CITY OF NOVI CITY COUNCIL JULY 8, 2024

SUBJECT: Consideration of the request of E & M Holdings, LLC, (Society Hill) to amend the 2001 Consent Judgment relating to a previously approved multi-family development located at 12 Mile and Novi Roads.

SUBMITTING DEPARTMENT: Community Development Department - Planning

Overview of the potential missed vernal pool identified in **Attachment B**. Also identified in the comments as Potential Missed Wetland 2.

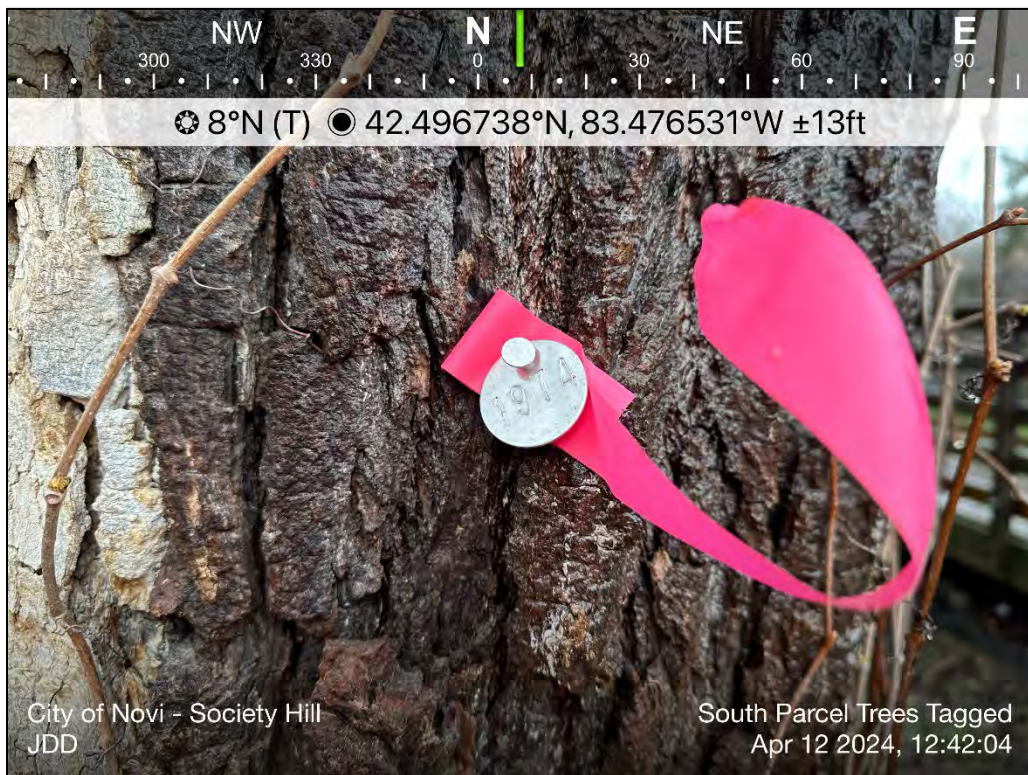
Overview of the potential missed wetland in **Attachment B**. Also identified in the comments as Potential Missed Wetland 1.

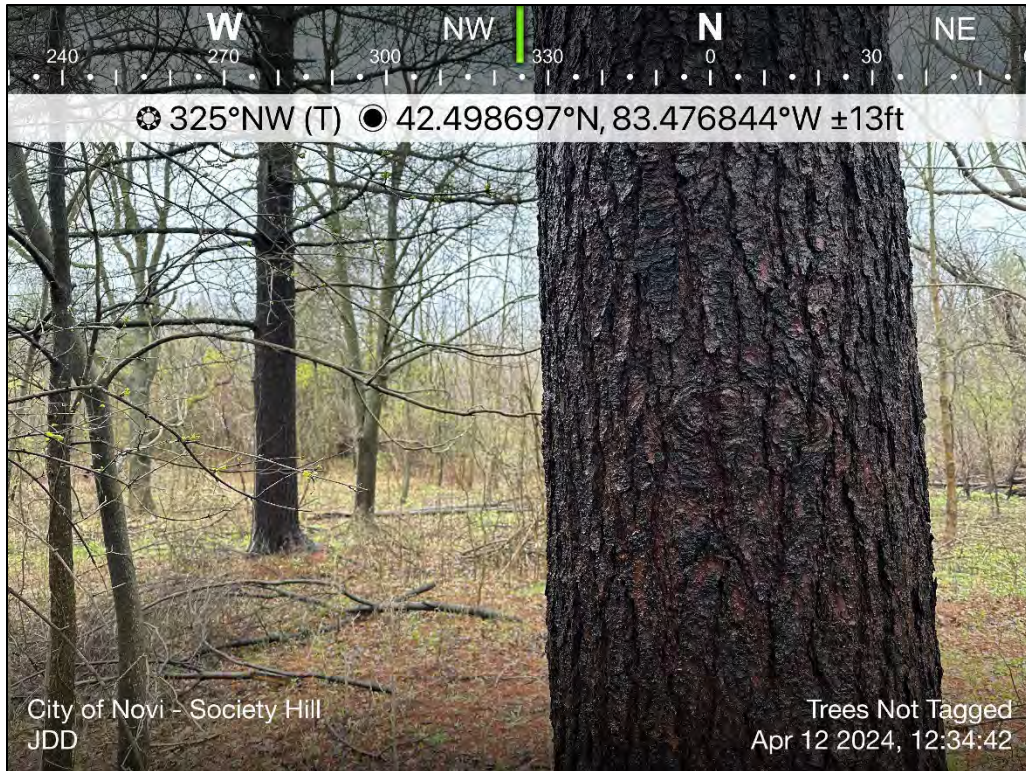
Overview of a tree tag that does not match the survey. This tree is approximately located around Tree 679 identified in the PSP. Tree tag reads as 4339.

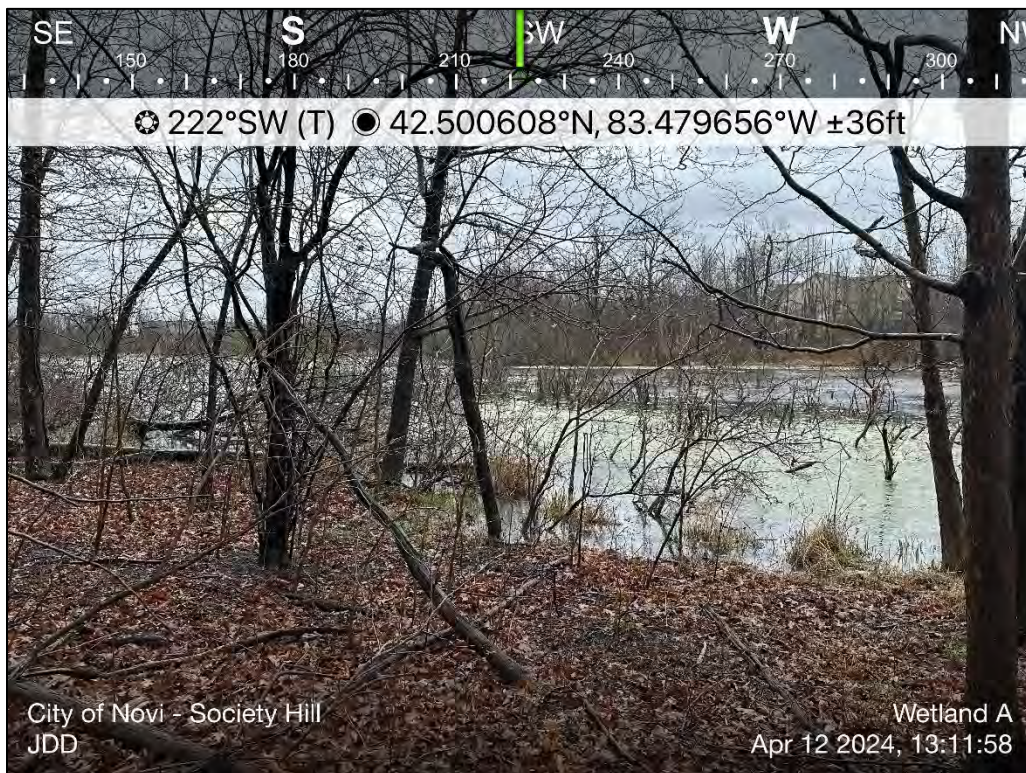
Overview of a tree tag that does not match the survey. This tree is approximately located around Tree 1104 identified in the PSP. Tree tag reads as 4367.

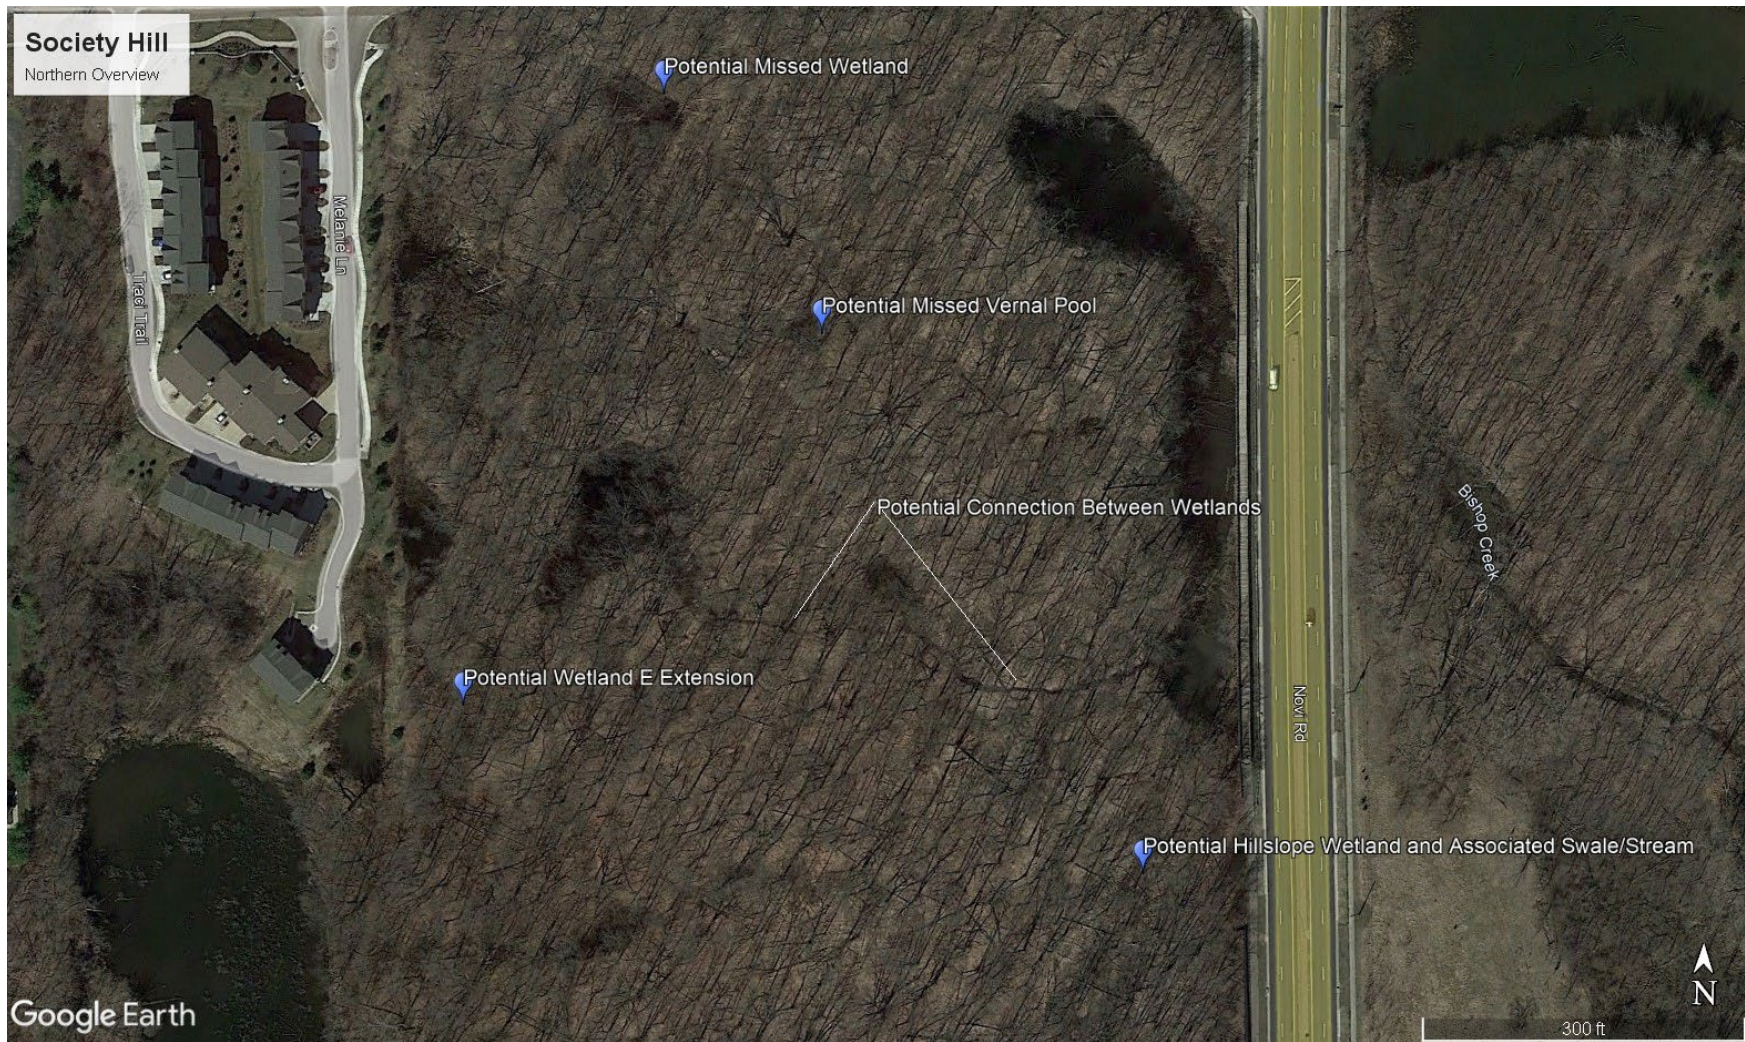
Overview of a tree tag that does not match the survey. This tree is approximately located around Tree 469 identified in the PSP. Tree tag reads as 395.

Attachment B
Wetland Resource Documents

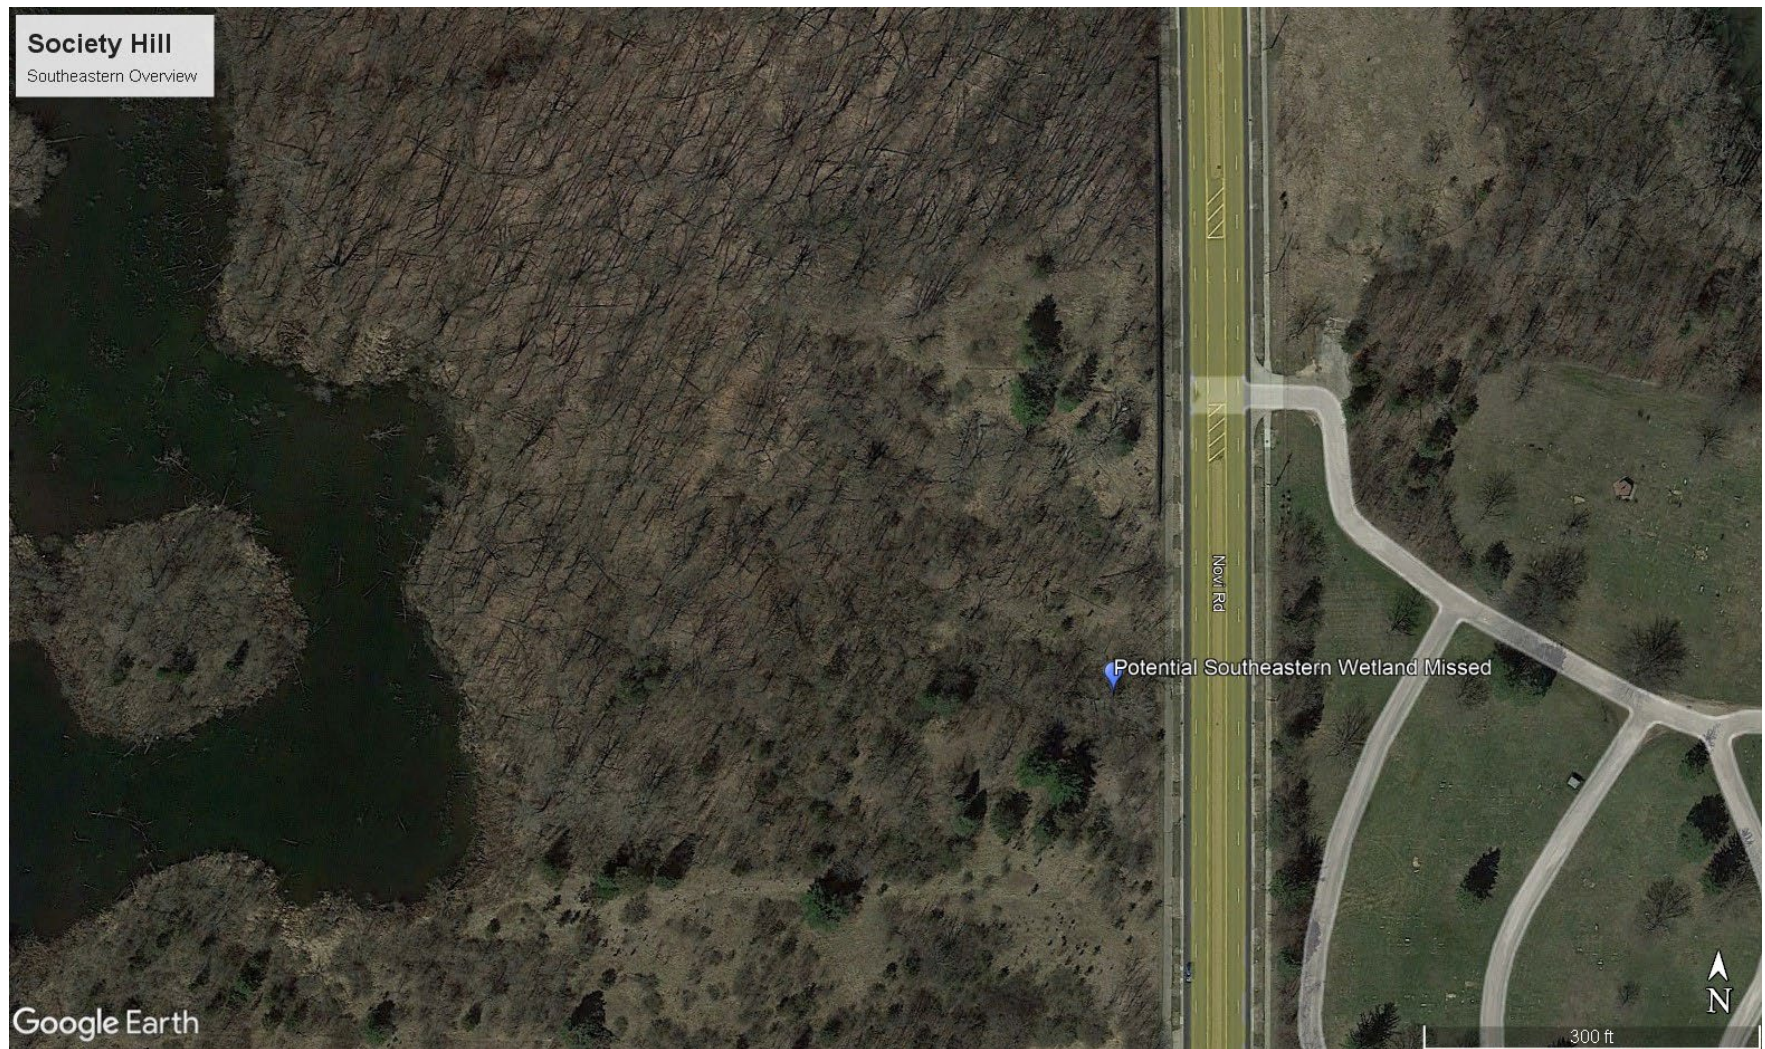
Overview of the northern portion of the site with potentially missed wetlands. Photographs of each area are included in **Attachment A**.
